County of Napa Planning Commission  
1195 Third Street  
Napa, CA 94559

RE: Agenda Item 9a Napa Pipe Project

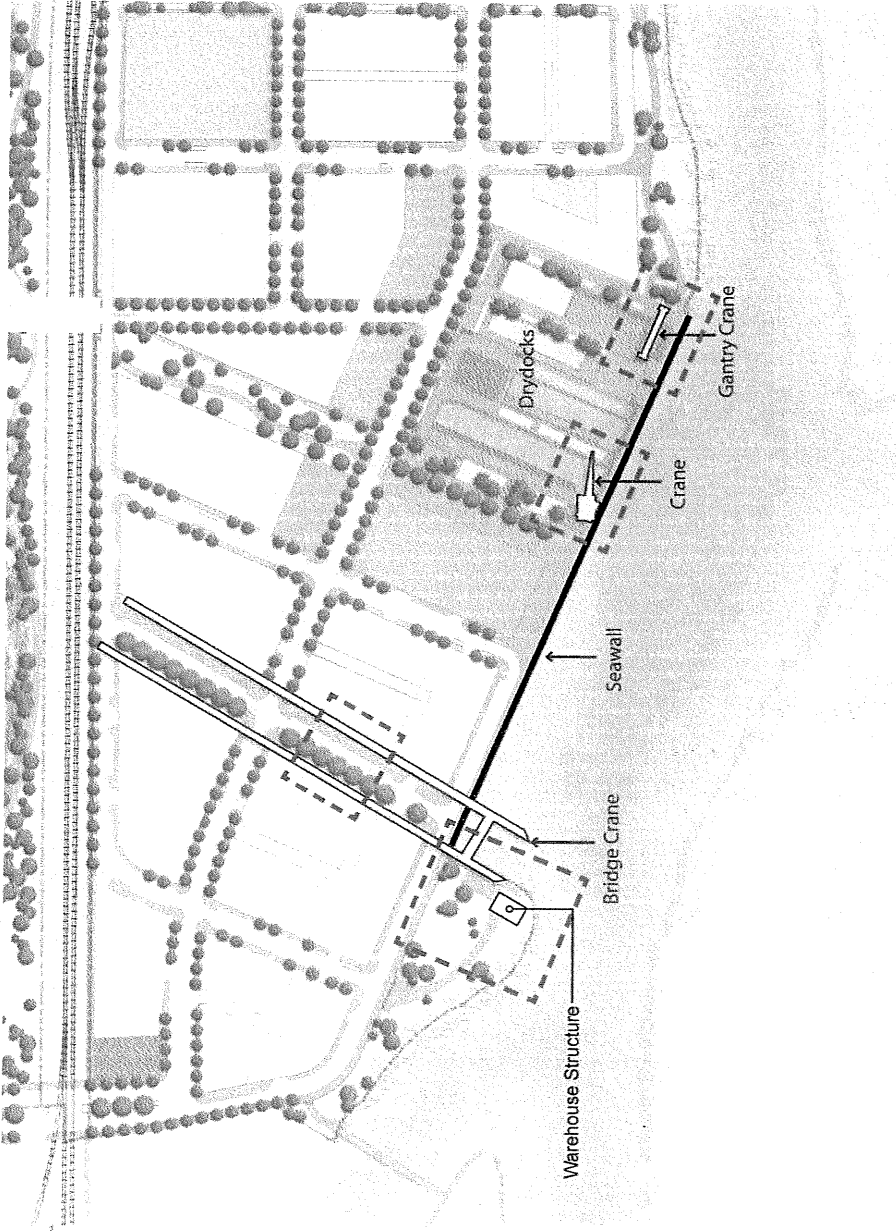
The long winding park to the East of the railroad tracks (P5) will be constructed in phase 2 but the pedestrian/bike rail crossing is only constructed in phase 4. What happens if phase 4 is delayed? As the largest park in the project why should the homeowners be responsible for maintenance of a park they cannot access? Is this a sustainable model?

Figure VI.2.f - DRYDOCKS

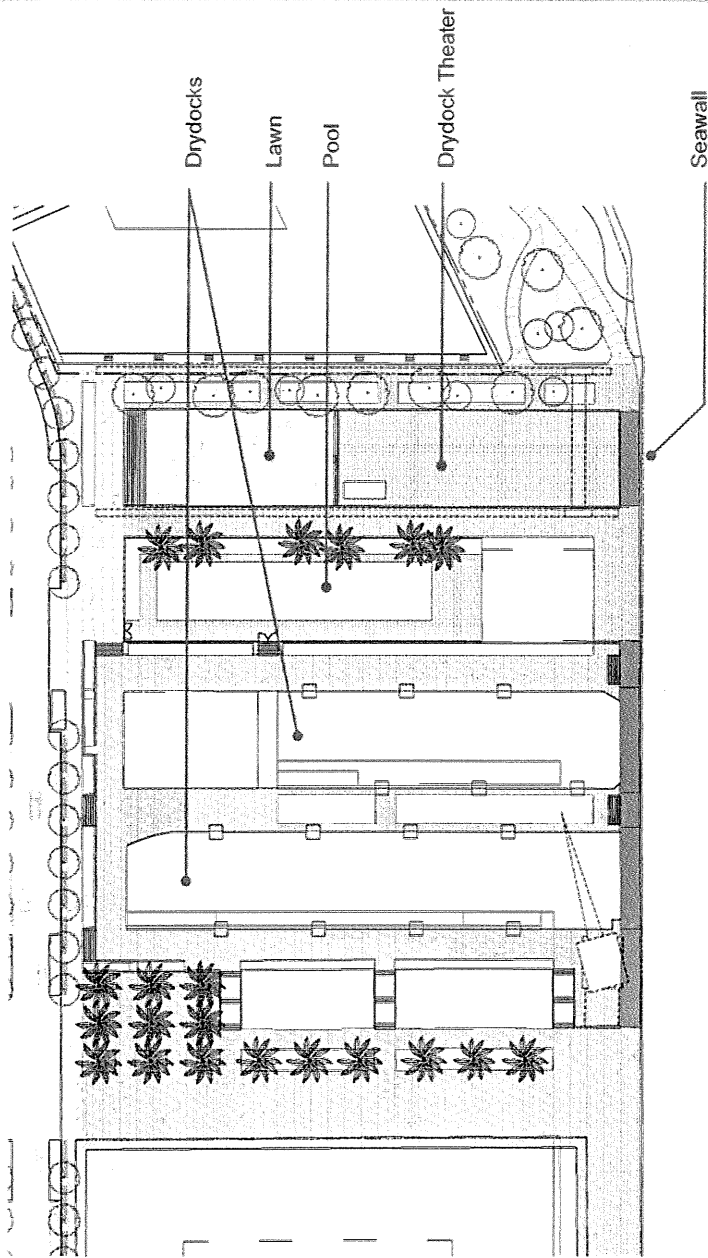
The development plan has one diagram representing a seawall from the Bridge crane to the Gantry crane that spans the drydocks (A). Yet another part of the development plan clearly states that the large doors for the two flooded drydocks will be permanently fixed in an open position (B). And only one drydock that will become a sunken theater will have the perimeter walls raised by 5'.

As I read these sentences, there will be no seawall south of the Gantry Crane. And why is the Southern flood gate positioned in the middle of a wetland that may flood?

How is this project REALLY being protected from potential flooding?
